# Review Insights on the Probabilistic Risk Assessment for the Limerick Generating Station

**U.S. Nuclear Regulatory  
Commission**

Office of Nuclear Reactor Regulation

Manuscript Completed: August 1984  
Date Published: August 1984

Figure 1 Estimates of the range of uncertainty on core damage frequency

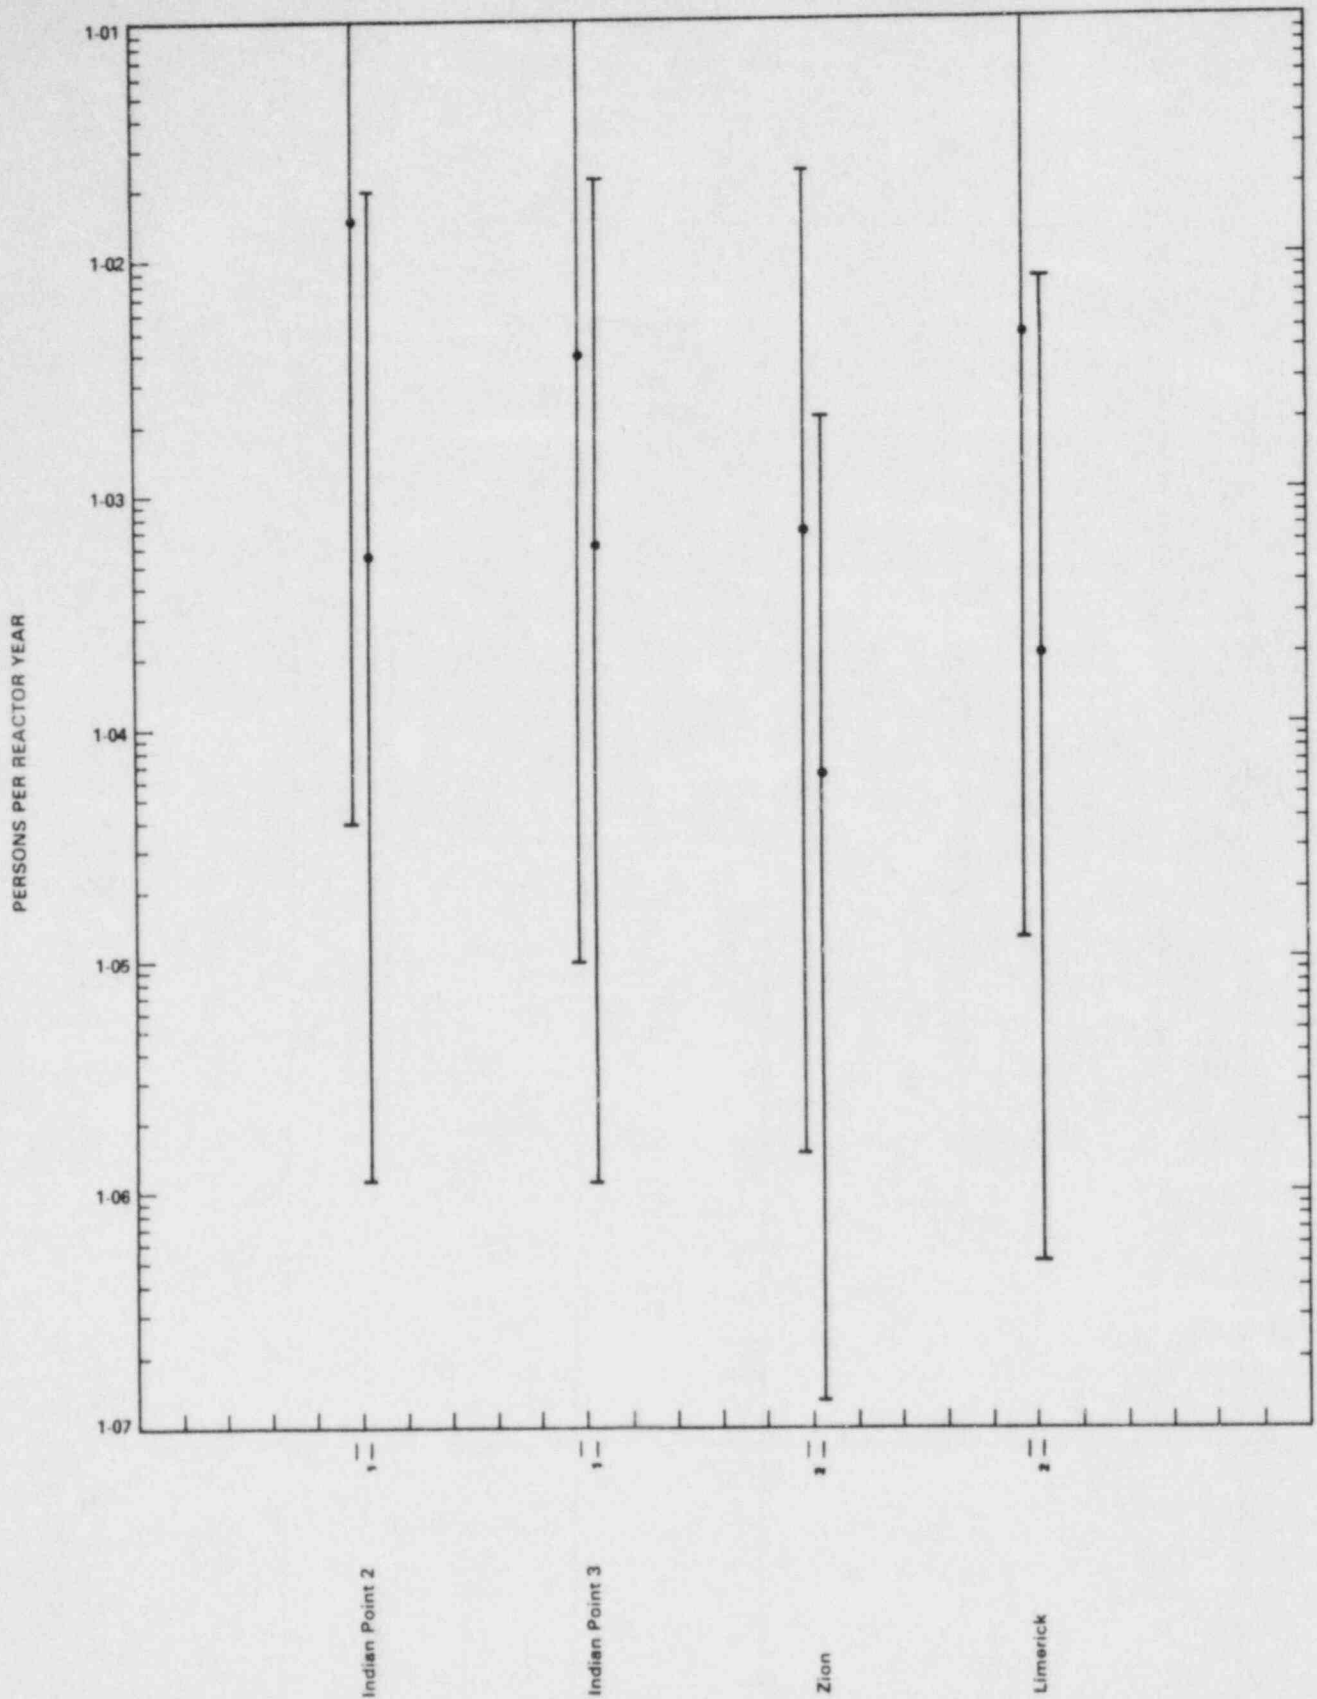
Both the applicant and BNL have performed sensitivity analyses and have identified potential sources of uncertainty and treated them using the applicable state-of-the-art methodologies. Figure 1 shows a perspective on the range of uncertainty associated with the core damage frequency, as estimated by the applicant and BNL. Note that BNL's estimate of the fifth to the 95th percentile probability range for the frequency of core damage from transients and LOCAs spans almost 2 orders of magnitude (7E-6 to 3E-4 per reactor year) and is greater than the corresponding estimate by PECO.

Figure 4 Comparison of Limerick core damage frequency with high density population plants - uncertainty range of internal and external events.

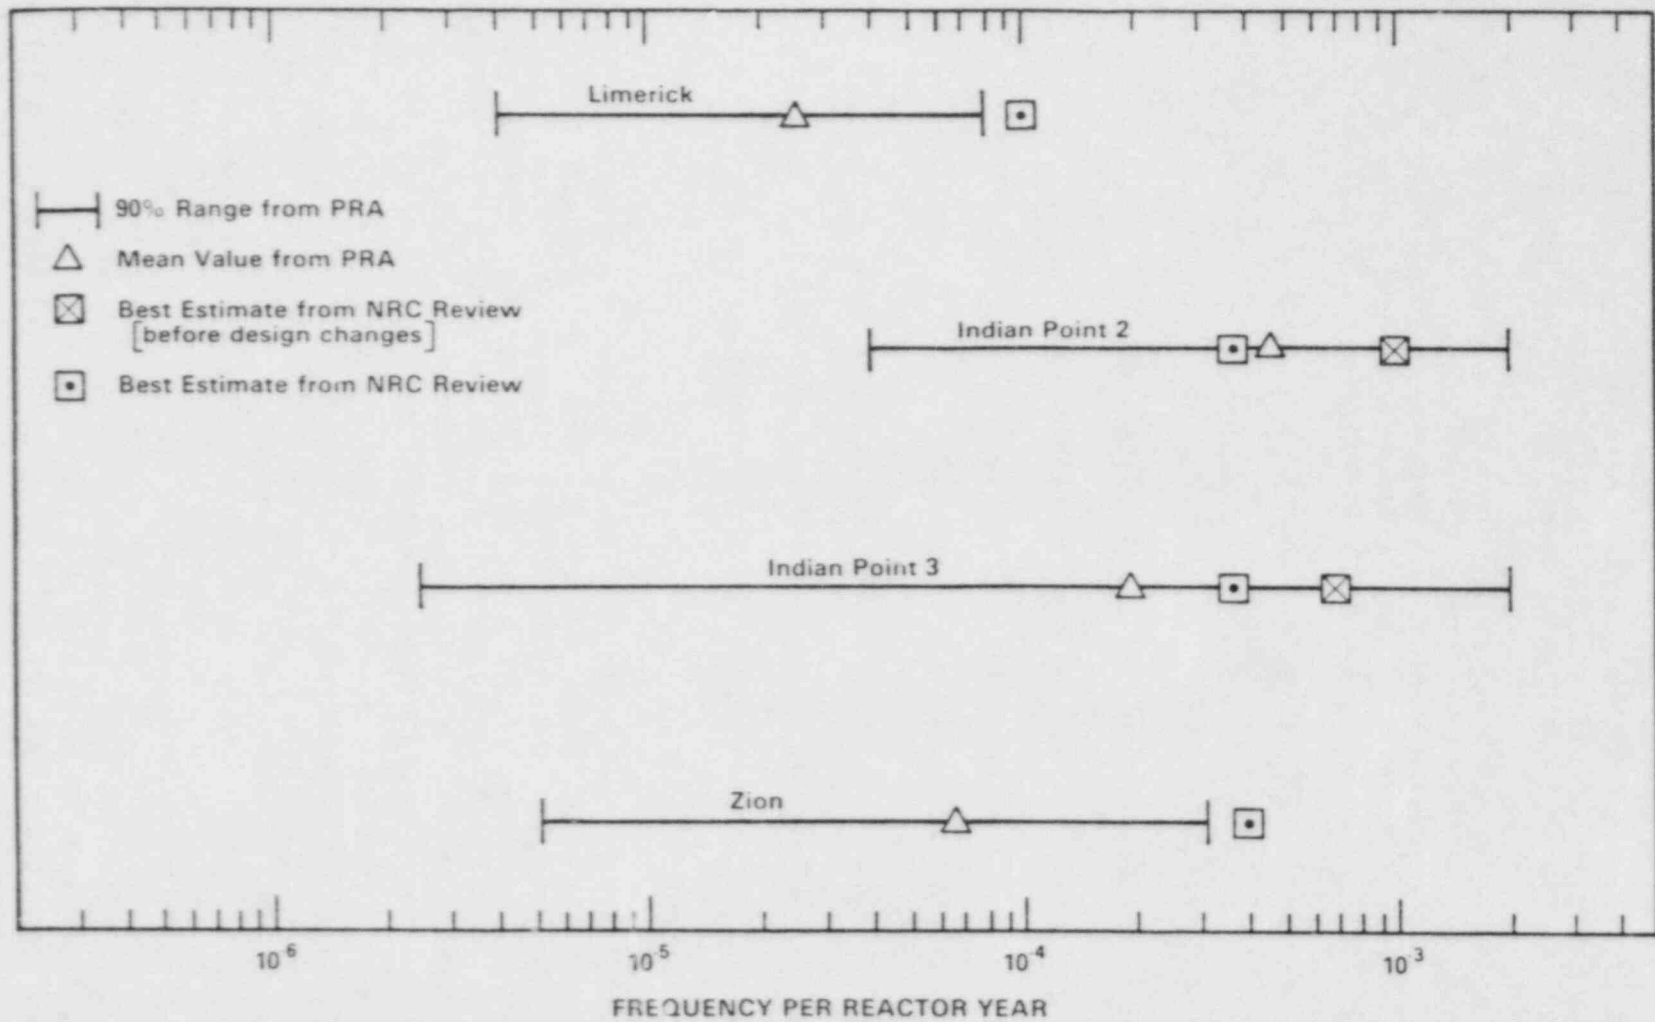
Although Figure 4 indicates that the Limerick core damage frequency is lower than that of other high population density plants, caution must be exercised when using these results since very large uncertainties exist in these analyses. No attempt has yet been made to adjust the results to compensate for inconsistent approaches or methods. Therefore, the appropriateness of the comparison may be questioned.
